## M088.0

### Snap-On Ferrite for BevMax 2 and BevMax 3 Venders

12/7/07

Figure 1

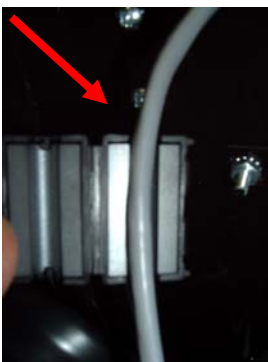
1. Open the Service Door.
2. Toggle Main Power Switch on the AC Distribution Box to the OFF Position.
3. Locate the Display Board on the Service Door. If the machine has a Bill Validator installed, the Display will be located directly behind the Bill Validator.
4. Locate the Display Harness.
5. Inspect the Display Harness near the Display to confirm there currently is no ferrite installed.
6. Follow the Display Harness towards the hinge side of the Service Door.
7. Open the latch on the side of the Ferrite (See Figure 1). Place the Display Harness in the groove of the Ferrite approximately 4" from the Display Connection (See Figure 2).

Figure 2 (Without Bill Validator installed)

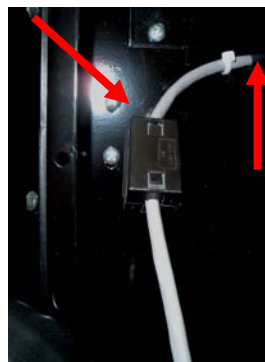
8. Snap Ferrite closed and ensure the latch locks the Ferrite in position.
9. Figures 2 and 3 show the final Ferrite placement with and without a Bill Validator installed.
